**THE IRREPARABLE ENVIRONMENTAL AND  
CULTURAL IMPACTS OF THE PROPOSED  
RESOLUTION COPPER MINING OPERATION**

**OVERSIGHT HEARING**

COMMITTEE ON NATURAL RESOURCES  
U.S. HOUSE OF REPRESENTATIVES

Thursday, March 12, 2020

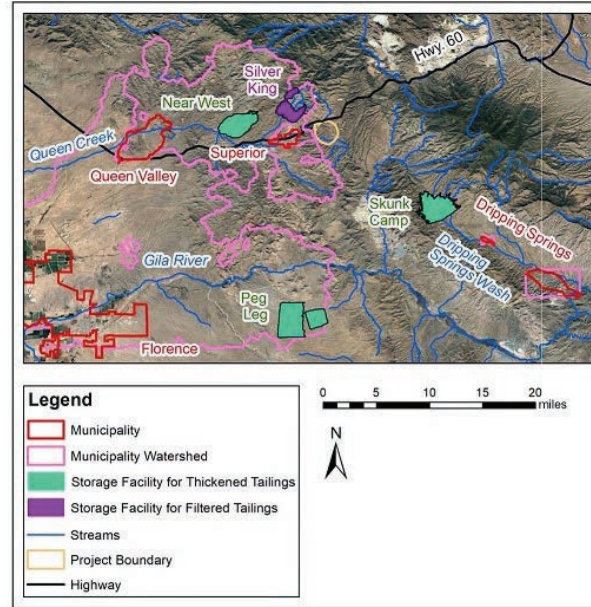
The DEIS presents five alternative plans for the tailings storage facilities for the proposed mine (USDA, 2019). By DEIS conventions, Alternative #1 is the “no-action” alternative. Alternative #2, the preferred alternative that was presented in the General Plan of Operations (GPO) (Resolution Copper Mining, 2014a-c), involves storing tailings thickened into a slurry (65 percent solids for scavenger tailings, 50 percent solids for cleaner tailings) at the Near West site behind a 520-foot-high tailings dam (see Fig. 4). Alternatives #2 and #3 are nearly spatially coincident at the Near West site (see Fig. 4). Alternative #3 involves slightly thicker scavenger tailings (70 percent solids) and a slightly lower dam (510 feet). Alternative #4 would involve the storage of filtered tailings (86–89 percent solids) at the Silver King site to a height of 1,040 feet (see Fig. 4, Table 1). The dam for the Silver King site would be a “structural zone” of tailings built around the perimeter (SWCA Environmental Consultants, 2018) and would be the tallest tailings dam ever constructed. (The current tallest tailings dam in the world is the 650-foot-high Quillayes Dam at the Los Pelambres Mine in Chile (Campaña et al., 2015)). Alternative #5 involves the storage of thickened tailings (60 percent solids for scavenger tailings, 50 percent solids for cleaner tailings) behind a 310-foot-high tailings dam at the Peg Leg site (see Fig. 4, Table 1). The final Alternative #6, which is the preferred alternative in the DEIS, involves the storage of similarly thickened tailings (60 percent solids for scavenger tailings, 50 percent solids for cleaner tailings) behind a 490-foot-high tailings dam at the Skunk Camp site (see Fig. 4, Table 1). The total volumes of stored tailings have been predicted as 1,315.45 million cubic yards for the sites storing thickened tailings and 1,188.98 million cubic yards for the site storing filtered tailings (see Table 1; USDA, 2019).

According to the DEIS (USDA, 2019), the design earthquake for the tailings dams would be the Maximum Credible Earthquake (MCE), which is defined as “the largest earthquake magnitude that could occur along a recognized fault or within a particular seismotectonic province or source area under the current tectonic framework” (FEMA, 2005). However, the DEIS also states without justification, “Analysis indicates Maximum Credible Earthquake is equivalent to 10,000-year return period [annual exceedance probability of 0.01%].” On the contrary, in the context of discussing criteria for determining the MCE at a particular location, FEMA (2005) states, “For high-hazard potential dams, movement of faults within the range of 35,000 to 100,000 years BP is considered recent enough to warrant an ‘active’ or ‘capable’ classification.” In other words, the MCE can be as rare as a 100,000-year earthquake, with a corresponding annual exceedance probability of 0.001 percent. In addition, nothing in the DEIS explains how the tailings dams will be built so that they will withstand the 10,000-year earthquake. For example, there is no seismic stability analysis of any of the proposed designs anywhere in the DEIS.

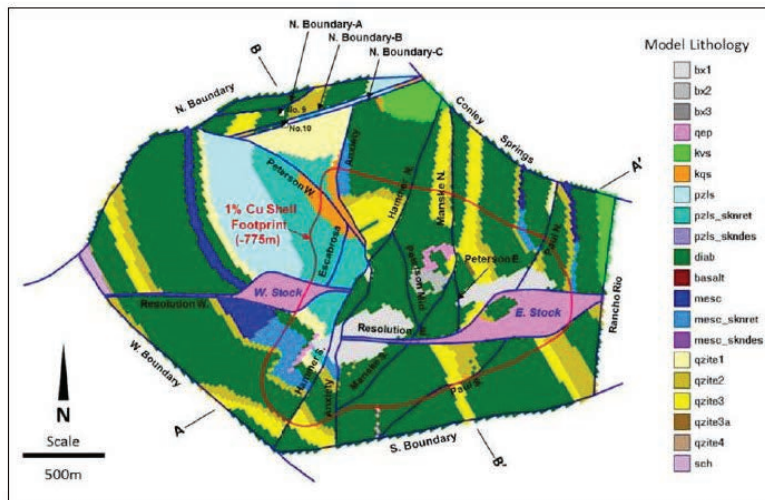
The actual data that were used in the subsidence modeling are not presented in any documents that have been provided by Rio Tinto. On that basis, there is no way for anyone not affiliated with Rio Tinto to repeat the subsidence modeling or to carry out his or her own subsidence modeling. Even the description of the data is inadequate for assessing the validity of the subsidence modeling. The most important information that is missing are the numbers of drill cores and the depths of the drill cores. The only exception to the lack of input data is the map of the geological faults that were used in the subsidence modeling (see Fig. 5). The primary control on the ability of block caving to transmit deformation to Apache Leap should be any faults that connect Apache Leap to the surface footprint of the block caving area, so that the most important fault is the West Boundary Fault (compare Figs. 3 and 5).

The superposition of the West Boundary Fault (as mapped in Fig. 5) onto a Google Earth image shows a pronounced lineament that is subparallel to the West Boundary Fault and offset from the fault by about 2,000 feet (see Fig. 6). The nearly parallel orientations of the West Boundary Fault and the lineament are certainly suggestive that the West Boundary Fault has been incorrectly mapped, and there is no other mapped fault that could correspond to the lineament (see Figs. 5–6). Unlike the mapped West Boundary Fault, the lineament intersects the caved rock zone (see Fig. 3), so that there is potential for deformation to be transmitted from the caved rock zone to Apache Leap. On this basis, there could have been an underestimation of the extent of the subsidence zone.

Figure 3.7.1-2. Desert Wellfield modeling analysis area and maximum (Alternative 2, left) and minimum (Alternative 4, right) modeled pumping impacts

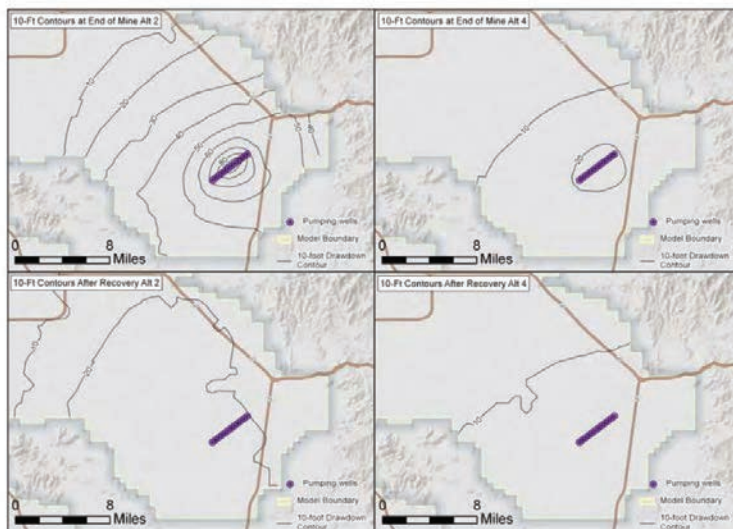
A map (or discussion) of the groundwater model area boundaries for the East Salt River Valley analysis area are never provided. The DEIS (p. 298) claims that figure 3.7.1-2 shows the groundwater model boundaries/analysis area of the East Salt River valley model. However, figure 3.7.1-2 (p. 298), below, shows only a zoomed-in, limited portion of this groundwater model area—making it impossible to know what the analysis area does or does not include.

Figure 3.7.2-1. Analysis area for groundwater and surface water quality

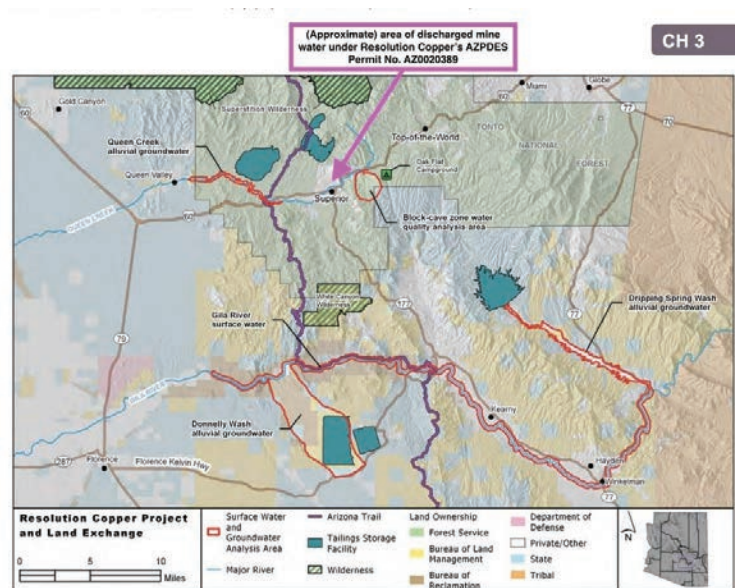
As shown below, the analysis area of the water quality model omits critical segments of Queen Creek. Figure 3.7.2-1 shows what is included in the water model analysis area studied under this section (supposedly encompassing where groundwater or surface water quality changes could potentially occur under the project). The area studied is extremely insufficient for many reasons, including that only about half of the length of Queen Creek between the block-cave zone and Whitlow Dam is included in the analysis area, despite Resolution Copper having an AZPDES permit No. AZ0020389 that allows them to dewater Shafts 9 and 10 and to discharge mine wastewater into the unstudied portion of Queen Creek. An excerpted copy of Figure 3.7.2-1 (DEIS p.347) is inserted below with an arrow showing the approximate location of discharge under AZ0020389. The DEIS does not address why this study failed to include such a large portion of Queen Creek, but this is another glaring omission that is contrary to science and which fails to comply with the requirements of 40 C.F.R. § 1502.16 and the very first requirement on the list of requirements for an EIS at Section 102(2)(C) of NEPA (P.L. 91–190).

Figure 3.7.1-4. Conceptual cross section of the groundwater systems

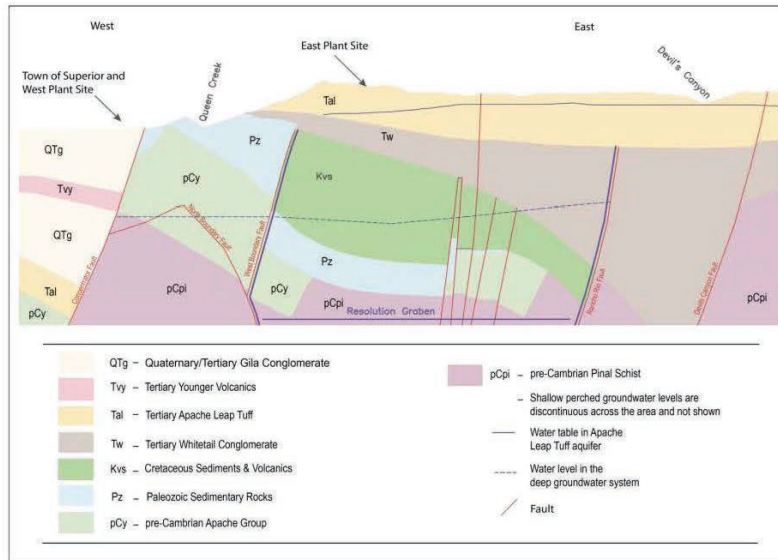
The Conceptual Cross Section of the Groundwater Systems (see figure 3.7.1-4, DEIS p. 305, reproduced above) shows no scale on either the X or Y axes. There is no way at all of knowing what depths or distances across, the data is meaningless without any of this. Despite a title referring to “Groundwater Systems,” the figure shows primarily geological features and only a thin floating line segments (with no axes to indicate location) to show water table locations. This image was taken from the General Plan of Operations and used here in the DEIS without any of these shortcomings being addressed.
